WOLF CREEK

ET 01-0008

Subject: Docket No. 50-482: Relocation of Technical Specification Cycle Specific Parameters to the Core Operating Limits Report

ATTACHMENT III
MARKUP OF TECHNICAL SPECIFICATION PAGES

Figure 2.1.1-1 (page 1 of 1)
Reactor Core Safety Limits

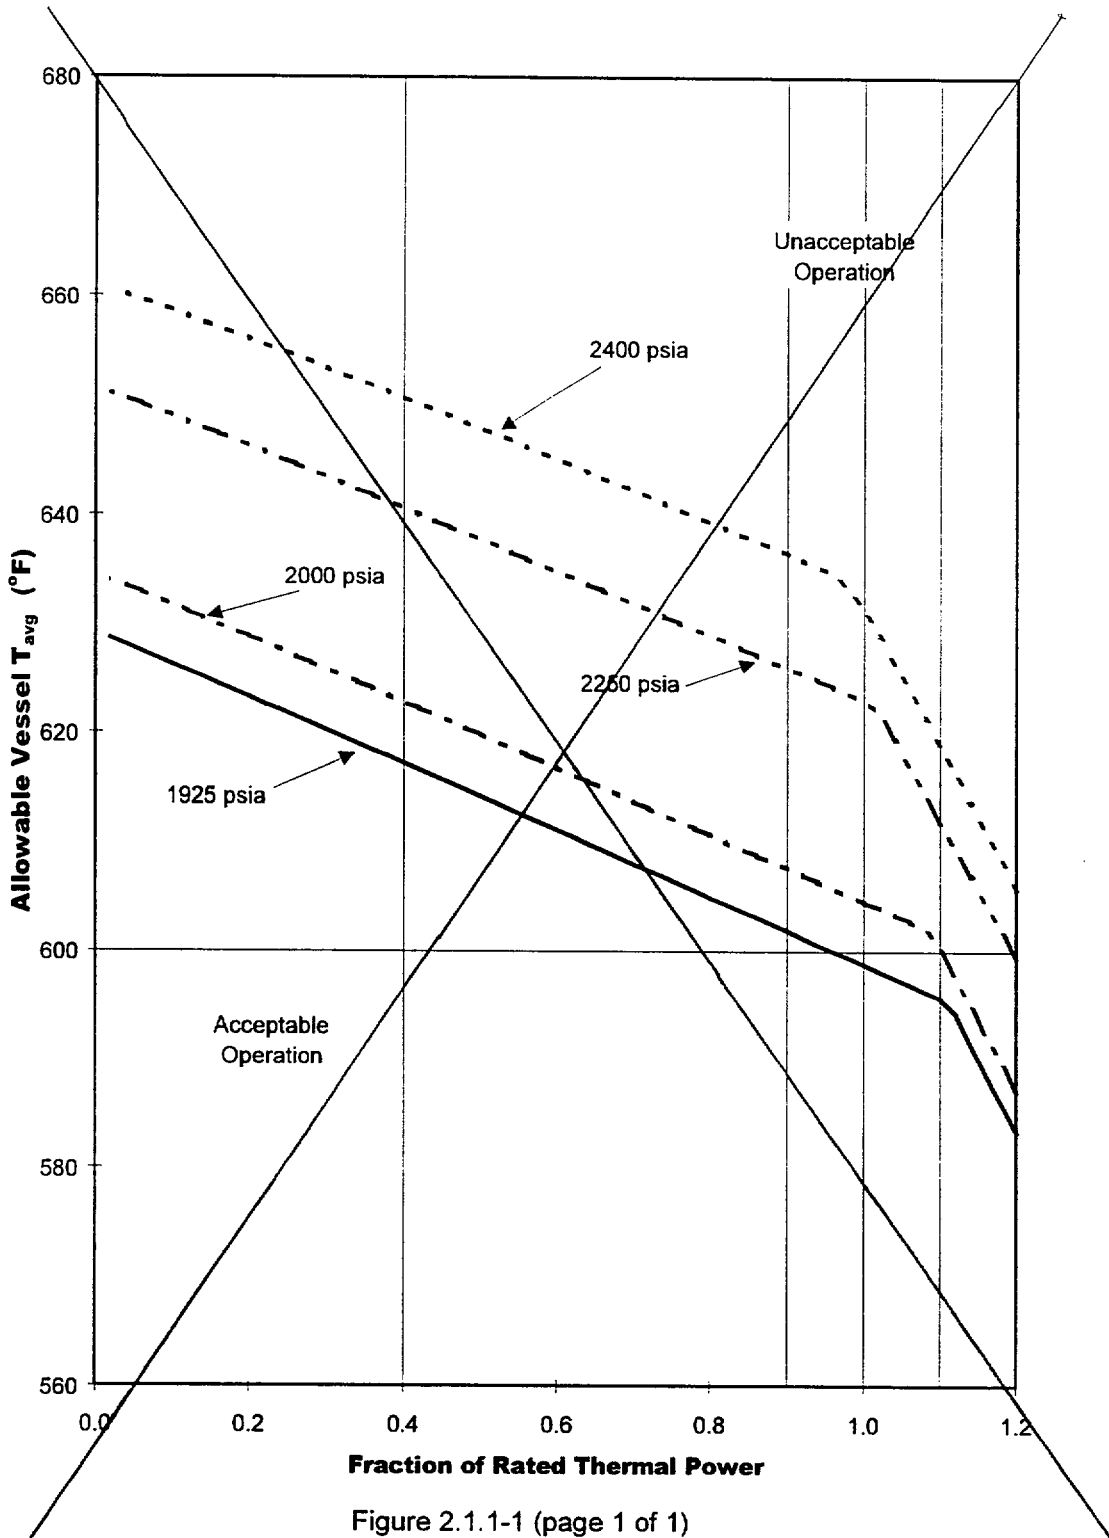
TS Figure 2.1.1-1, "Reactor Core Safety Limits," is being relocated to the COLR, and is being replaced with more specific fuel departure from nucleate boiling ratio (DNBR) and peak fuel centerline temperature safety limits.

TS Figure 2.1.1-1, "Reactor Core Safety Limits," presents the limiting RCS average temperature conditions as a function of pressurizer pressure and fractional RATED THERMAL POWER. This figure is included in the TS to satisfy the requirements of 10 CFR 50.36 which states that "safety limits for nuclear reactors are limits upon important process variables that are found to be necessary to reasonably protect the integrity of certain physical barriers that guard against the uncontrolled release of radioactivity." The Reactor Core Safety Limits figure provides the relationship between RCS average temperature, pressurizer pressure and RATED THERMAL POWER level, and the DNB design basis. If a Condition I or II event were to occur, the Reactor Core Safety Limits figure could be used to determine whether or not the DNB design basis was met.

Because the Reactor Core Safety Limits figure is used in the generation of the OT Δ T and OP Δ T reactor trip setpoints, it contains the hot-leg boiling limits, which are not true safety limits. The hot-leg boiling limits preclude saturation conditions to ensure that the measured ΔT remains proportional to thermal power. The DNB limits of the figure are based on the DNBR safety analysis limit and assume a specific RCS flow rate and a symmetrical reference axial power shape. Based on this figure, the gains (K_1 through K_6) of the OT Δ T and OP Δ T reactor trip setpoints are generated. For non-symmetrical power shapes that are more limiting than the reference axial power shape, the $f(\Delta I)$ penalty functions reduce the corresponding tripsetpoints. Thus, the OT Δ T and OP Δ T reactor trip setpoints ensure that the Reactor Core Safety Limits figure is satisfied during a Condition I or II event and ensure that for non-symmetrical axial power shapes the DNB design basis is satisfied. Because the OT Δ T and OP Δ T reactor trip setpoints are based on the Reactor Core Safety Limits figure, the only way to violate the figure is under the postulated condition where both trains of the Reactor Protection System (RPS) do not function as designed. Operation of the RPS and the Main Steam Safety Valves (MSSVs) ensure that the DNB design basis is satisfied for any Condition I or II transient, independent of the Reactor Core Safety Limits figure.

Relocating the Reactor Core Safety Limits figure to the COLR eliminates the possibility of reaching an incorrect conclusion concerning whether or not a safety limit has been violated for a Condition I or II event. Additionally, removal of the Reactor Core Safety Limits figure prevents the possibility of misusing the Reactor Core Safety Limits figure to define an "acceptable" operating configuration that could result in the plant being placed in an unanalyzed condition.

It is proposed that the Reactor Core Safety Limits figure be replaced with the DNB design basis limit and the fuel centerline melting limit as these limits are criteria that must be satisfied for all Condition I and II transients. Confirming that the RPS and the MSSVs are functioning as designed will ensure that both the DNB design basis and fuel centerline melting criteria are satisfied for any Condition I or II event. With this approach, the chance of reaching an incorrect conclusion with respect to the safety limits would be greatly reduced, if not eliminated.

the CLR; and the following SLs shall not be exceeded:

2.1.1.1 The departure from nucleate boiling ratio (DNBR) shall be maintained ≥ 1.23 for the WRB-2 DNB correlation, and ≥ 1.30 for the W-3 DNB correlation.

2.1.1.2 The peak fuel centerline temperature shall be maintained $\leq 5080^{\circ}\text{F}$, decreasing by 58°F per 10,000 MWD/MTU of burnup.

Table 3.3.1-1 (page 5 of 6)
 Reactor Trip System Instrumentation

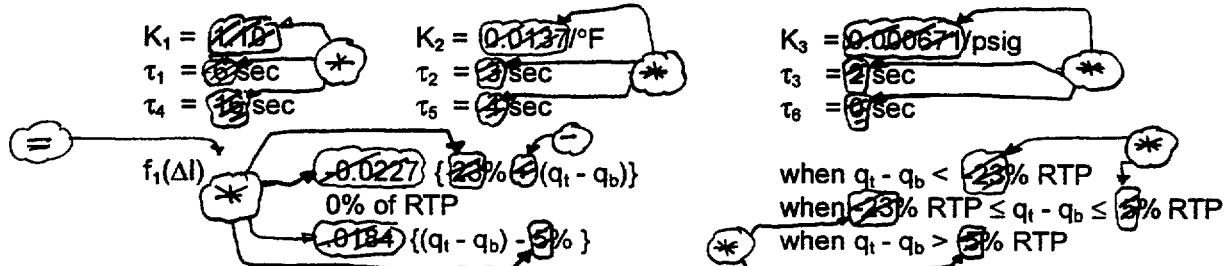
TS Table 3.3.1-1, Note 1: OT ΔT , and Note 2: OP ΔT , setpoint parameter constant (K_1 through K_6) values, dynamic compensation time (τ_1 through τ_7) values, T' , T'' , P' , and the breakpoint and slope values for the $f(\Delta I)$ penalty functions for the trip setpoints are being relocated to the COLR.

Relocation of the OT ΔT and OP ΔT setpoint parameter values to the COLR minimizes the chance that a reload-related parameter change would necessitate a TS change. In addition, significant DNB and operating margin currently utilized in the setpoints that is unnecessarily allocated and thus unavailable could be utilized to enhance plant operating margins, enhance the OT ΔT and OP ΔT setpoints, and increase the flexibility of the core designs without any reduction in the margin of safety.

The values denoted with * are specified in the COLR.
